INTEGRATIVE GENOMICS BUILDING PROJECT

Response to Comments

April 2015

FIGURE 1.

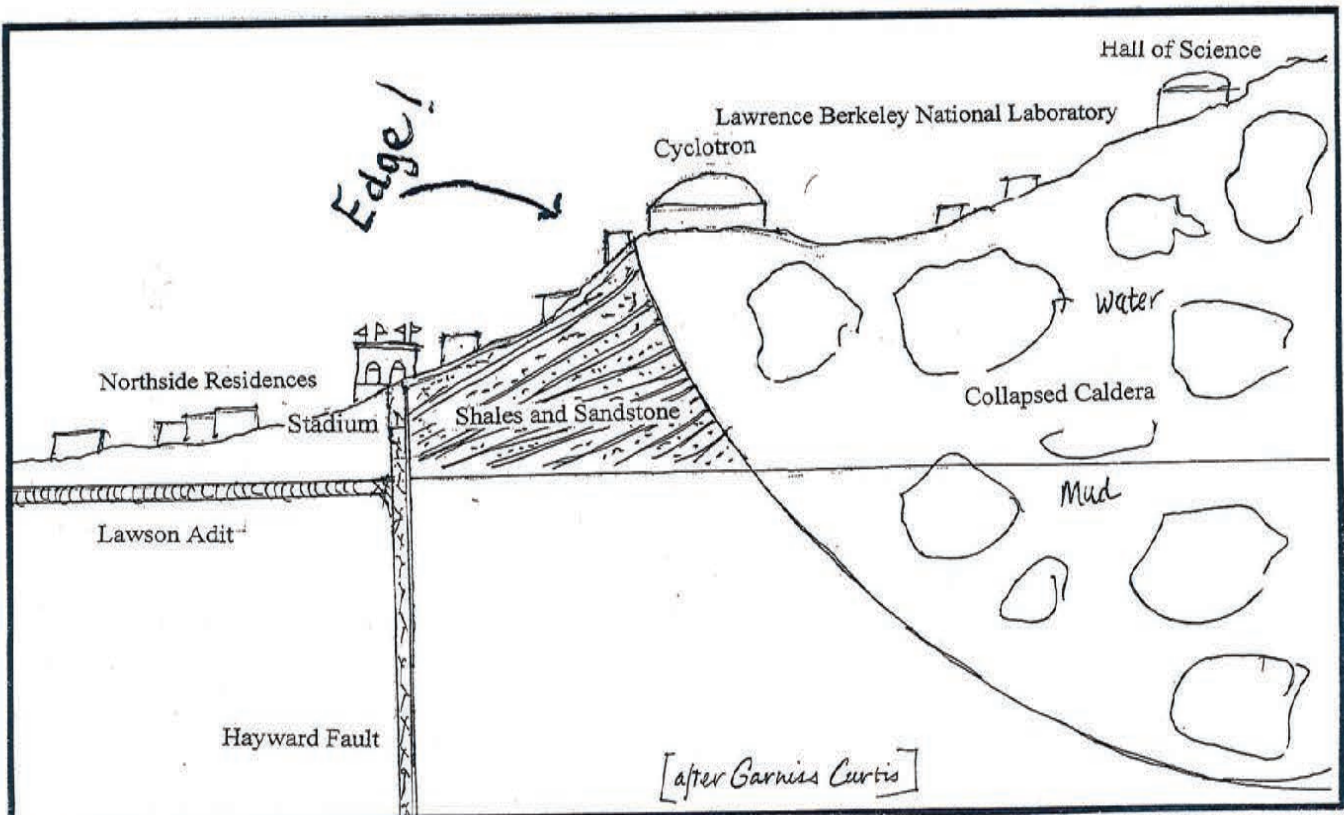
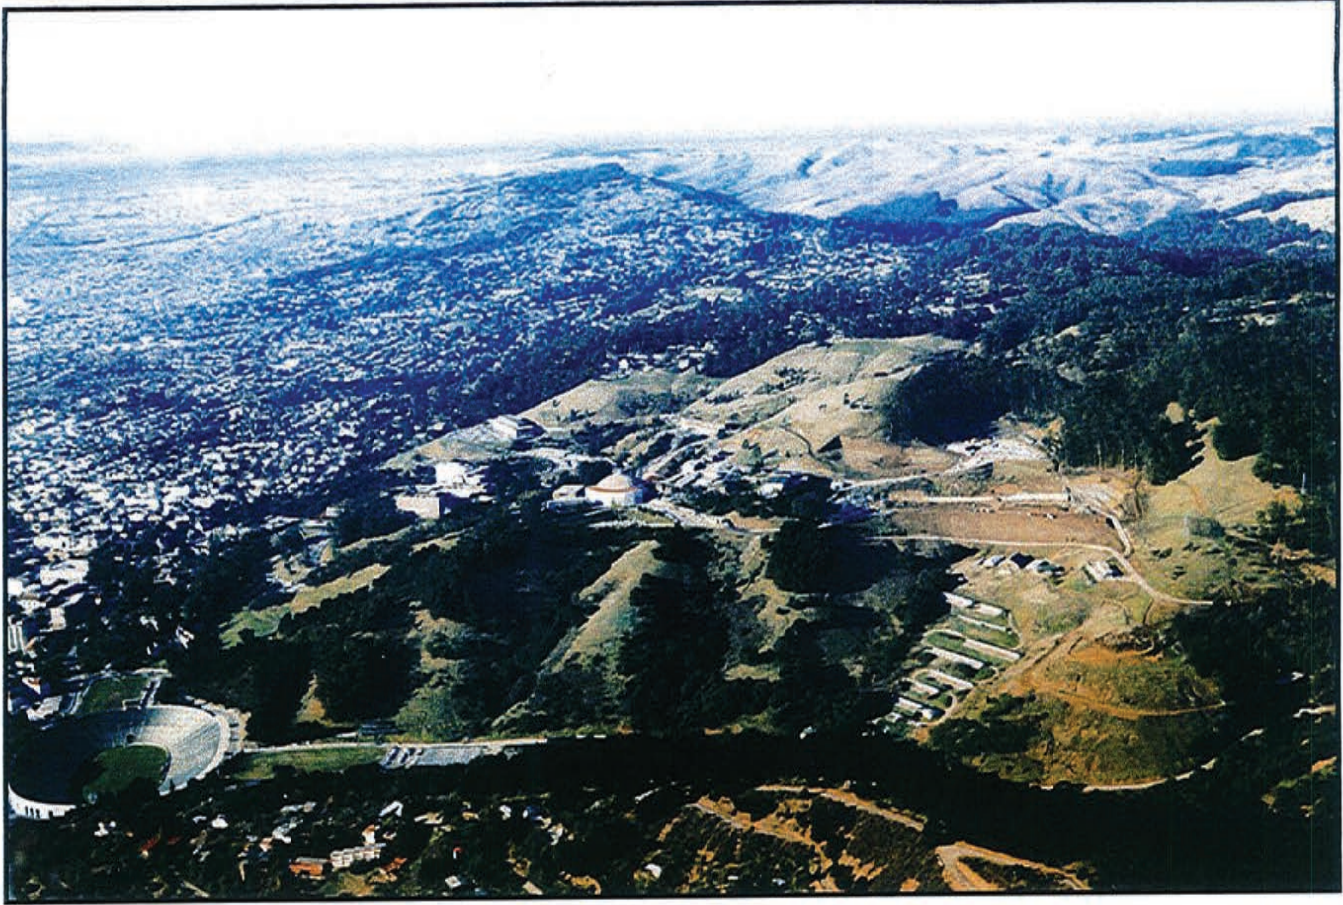
Figure 1., following the letter by Professor Curtis, shows his rendering of the LBNL site, an area between the Hayward Fault and the Lawrence Hall of Science, " where volcanic rocks underlying most of the Lawrence Lab complex fill an old crater, a collapsed caldera. The old volcano that once rose above these rocks collapsed after the expulsion of a very large amount of rhyolite ash, now largely removed by erosion. The volcanic rocks broke up as the collapse occurred and many show crushing and deformation and are mixed with large amounts of ash and volcanic fragmental debris, this material should never have been built on as it is so clayrich and unconsolidated."

With respect to aquifers and/or perched bodies of subsurface water, particularly in the volcanic rock, that are depicted in Figure 1 (included in the comment letter), hydrogeologic conditions at LBNL have been thoroughly investigated as part of LBNL's Environmental Restoration Program (ERP). These investigations have found that, as is typical throughout the San Francisco Bay Area, groundwater exists at LBNL within pores between sediment particles, such as between the grains of sand in sandstone, and rock fractures that are generally "smaller" to "much smaller" than a millimeter across. The investigations have also determined that the volcanic rock at LBNL is among the rock units with the highest permeability at the site, but well within the range of permeabilities for geologic materials in general. In addition, high permeability is not recognized by engineering geologists and geotechnical engineers as correlating significantly with slope instability. For instance, drainage of groundwater relieves the water pressure that contributes to slope instability, and groundwater drains more quickly from higher permeability materials. While groundwater conditions at LBNL can contribute to slope instability, particularly during and after intense precipitation events, no particularly adverse groundwater conditions relative to other hilly locations in the Bay Area have been encountered.

Geologic maps and cross sections contained in the geotechnical investigation report for the IGB (A3GEO 2014) indicate that the IGB site is not underlain by volcanic rocks. Bedrock that underlies the IGB site is of the Tertiary Orinda Formation, which is a sedimentary rock unit. Borings deep as 144 feet have been drilled from the level of the pad on which the IGB is planned to be sited. Data from the borings provide no evidence of volcanic rocks, large voids, or unstable geologic conditions at the planned location of the IGB. In short, the planned IGB site has been extensively investigated and found to be geologically stable and well-suited for the planned construction.

FIGURE 18a. ZONES OF CONCERN FOR GROUNDWATER PLUME EXPANSION ALONG COMPILED FAULTS, BEDROCK CONTACTS, LANDSLIDES, AND OTHER FACTORS THAT MAY INFLUENCE PLUME EXPANSION

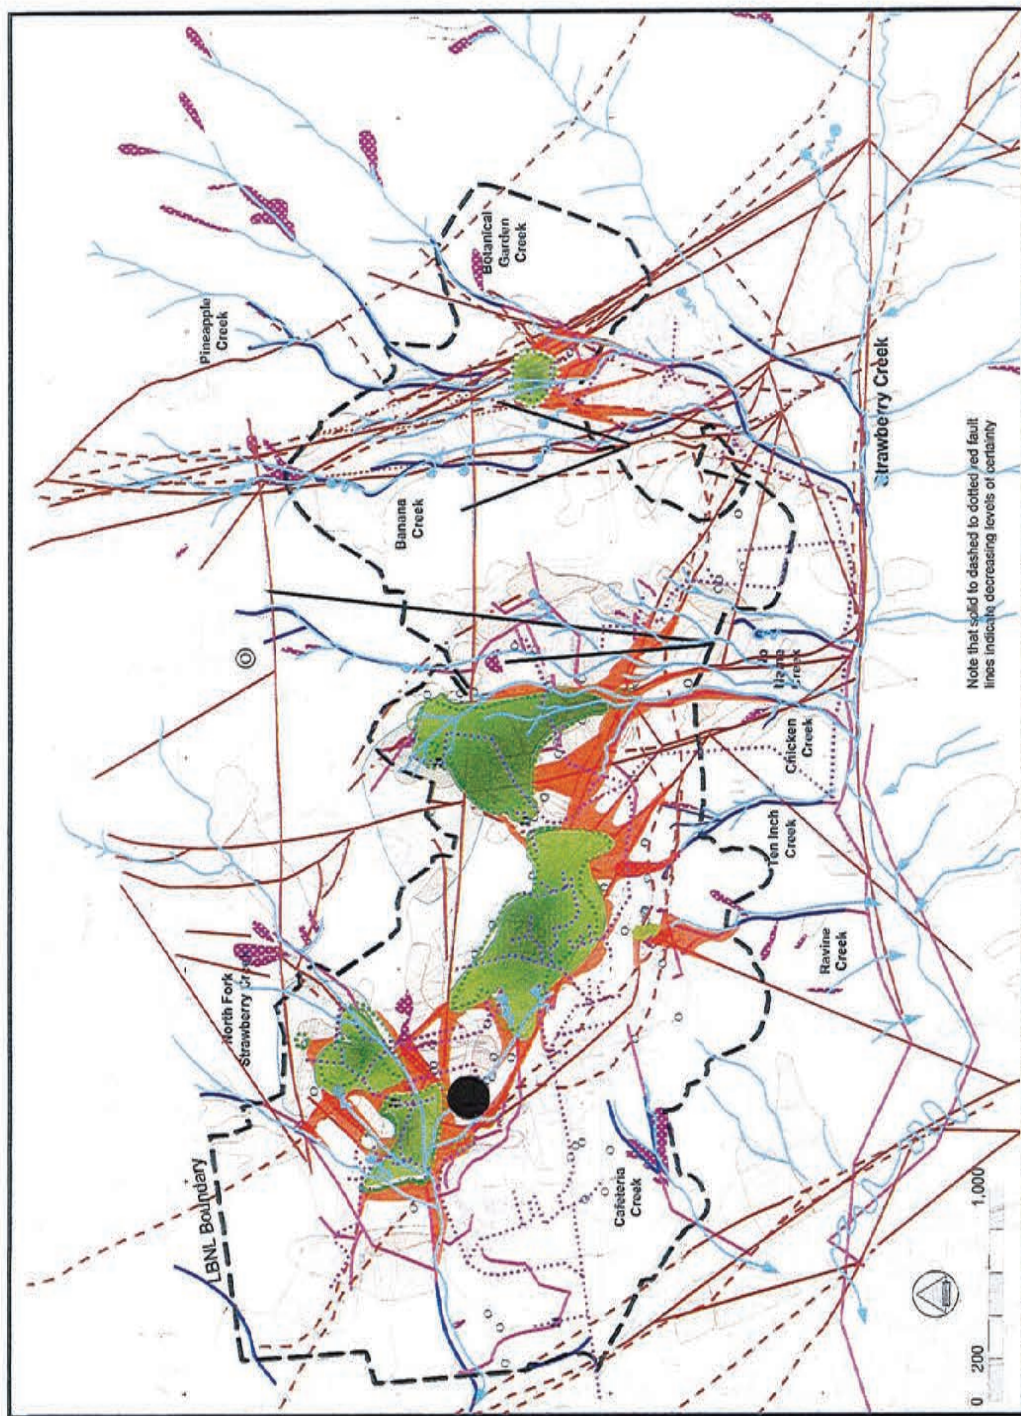
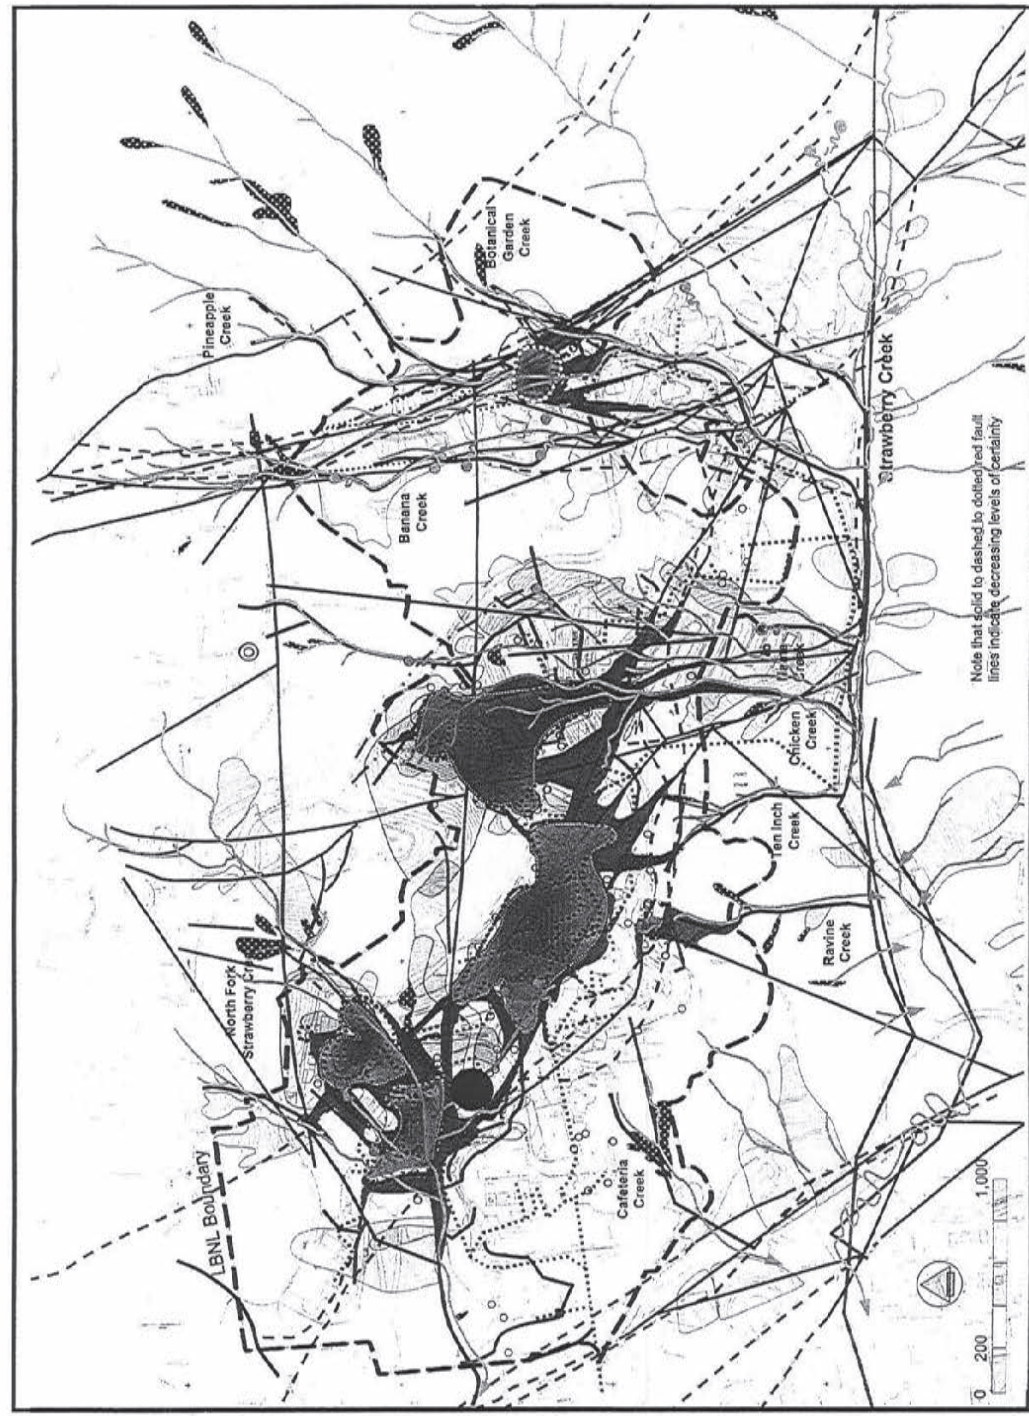
WE SHOW POSSIBLE CONTAMINANT MIGRATION ZONES AT LBNL ALONG FAULTS, BEDROCK CONTACTS AND LANDSLIDE AREAS (SEE ATTACHMENT 7.) ~ IT IS CLEAR THAT ALL OF THE CONTAMINANT PLUMES OF THE WESTERN / CENTRAL PORTION OF LBNL, IF NOT YET, WILL ULTIMATELY JOIN, AND IT APPEARS THAT THE BEVATON COMPLEX AREA MAY BE THE CENTER FOR THESE WATERS. (SEE ATTACHMENT 8.)

UC LBNL also notes that the maps provided by the commenter contain a conglomeration of apparent faults and other geologic features as identified by a wide variety of sources over a period extending back into the 19th century. Many of the faults and features identified in these maps have not been verified by independent geologists and technical specialists who have been retained by the University to investigate current conditions. The plans and analyses used by UC LBNL for the IGB and other projects on the LBNL site rely on current and verified sources.

FIGURE 20a. VARIOUS COMPILED SITE CONDITIONS AT FUTURE BUILDING SITES OF LBNL'S LONG RANGE DEVELOPMENT PLAN. SEE NEXT PAGE FOR MAP LEGEND. NOTE THAT SOLID TO DASHED TO DOTTED RED LINES INDICATE DECREASING LEVELS OF CERTAINTY.

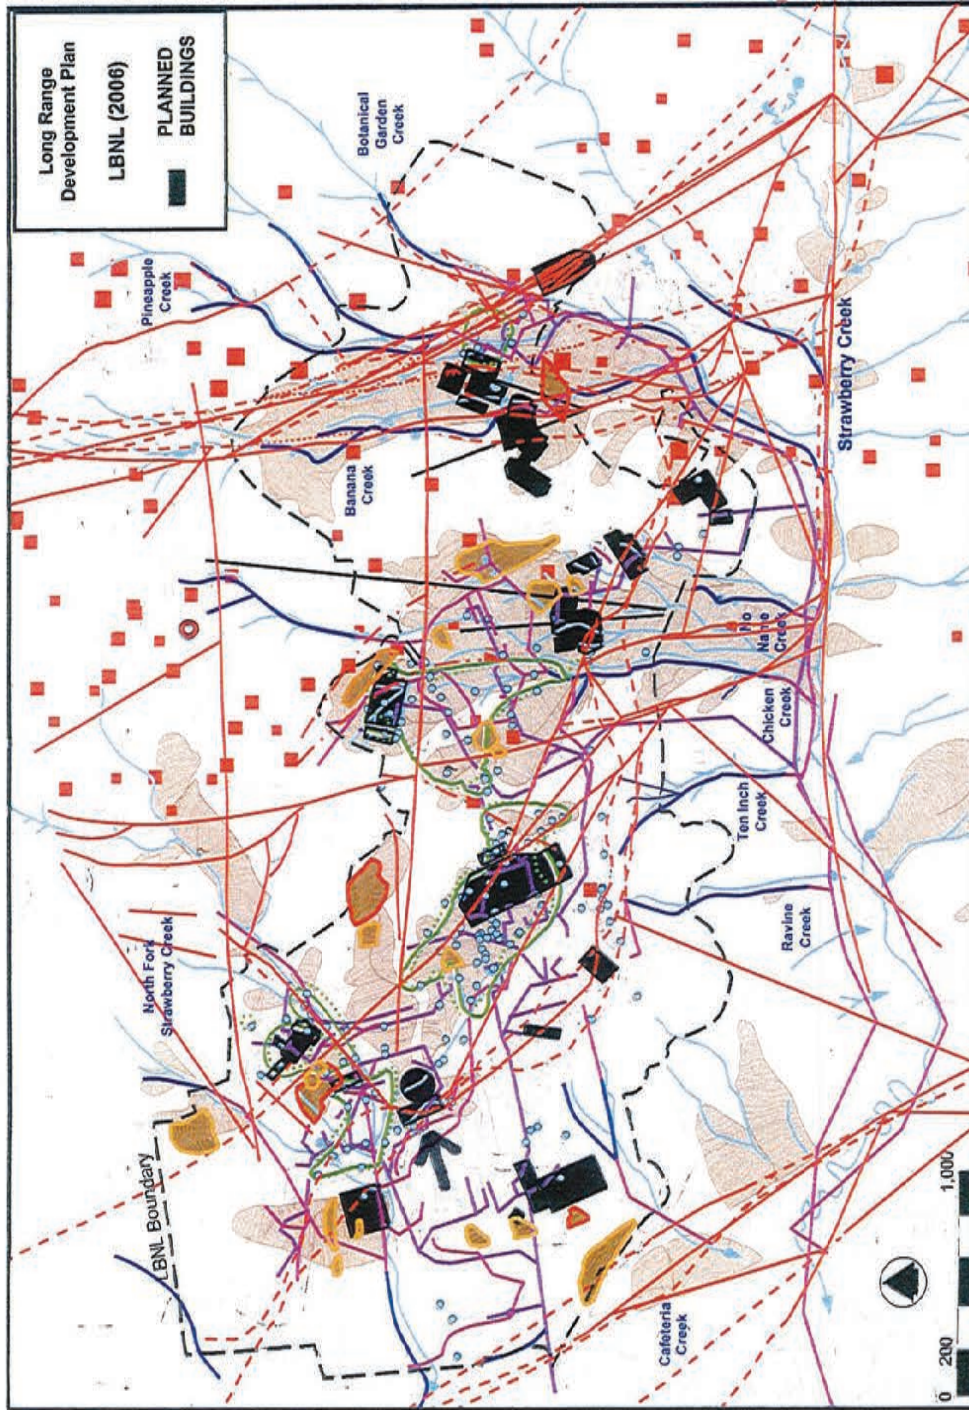
— CONTRARY TO DTSC'S FACTSHEET — LBNL IS
PLANNING MAJOR DEVELOPMENT, 2 HUGE
STRUCTURES TO BE BUILT ON THE BEVATRON
COMPLEX DEMOLITION SITE (SEE ATTACHMENT 9.)

The commenter's contention that two "huge structures (are planned) to be built on the Bevatron complex demolition site (see Attachment 9)" appears to be based on a literal reading (and thus a misinterpretation) of the 2006 LRDP EIR "Illustrative Development Scenario." (The "Attachment 9" figure included by the commenter is a diagram based on the 2006 LRDP Illustrative Development Scenario).
